<b>Title: Upgrade Intercooler Strut Attachment</b>		
<b>AG-SB-2025-01-B-EN</b>	<b>Effective Date: 01.11.2025</b>	<b>Compliance Category:</b>
<b>Applicability</b>		<del>A - MANDATORY</del> <b>B – RECOMMENDED</b> <del>C - OPTIONAL</del>
<b>Aircraft type &amp; model:</b> AutoGyro Calidus with ROTAX® 916is engines	<b>Affected Serial number(s):</b> C00588            C00592 C00589            C00593 C00590            C00596 C00591	
The maintenance manual to be referenced is this stated or subsequent issue.		As per AutoGyro website
<p>This form is the response from AutoGyro GmbH either against a problem found in the product in service requiring a containment or rectification action, or as service information for aircraft modification incorporation. For help, contact <a href="mailto:airworthiness@auto-gyro.com">airworthiness@auto-gyro.com</a>.</p>

**Reason and overview of the Service Bulletin (cause of problem if known)**

5) Overview:

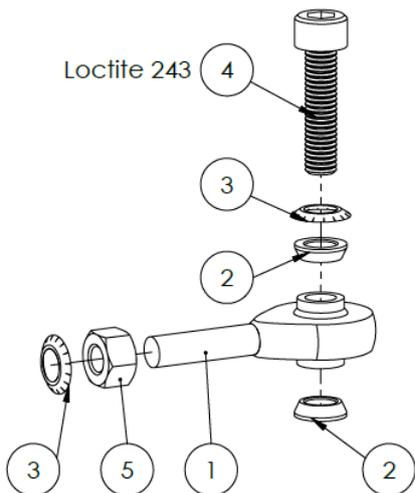
Market feedback has shown that this strut attachment may occasionally fail due to engine vibration. The failure has no effect on airworthiness or flight safety, but is undesirable. This Service Bulletin describes the retrofitting of an improved version in which the rigid eyebolt is replaced with a rod end. This allows for better absorption of the natural vibrations of the affected components.

5	1	20044	M6	M6
4	1	20061	M6x25	M6x25
3	2	20009	Safety washer M6	Schnorrzscheibe M6
2	2	20375	Spacer 10-2,8/6 F	Distanzbuchse 10-2,8/6 F
1	1	20095	Rod end KA 6-D	Kugelgelenkkopf KA 6-D
Ref.-No.	Qty.	Internal ID	Name (engl.)	Name (ger.)

6) Pre-assemble the ①rod end with ⑤nut and ③safety washer according to the drawing above and screw it into the support strut **at least 5 turns/threads.**
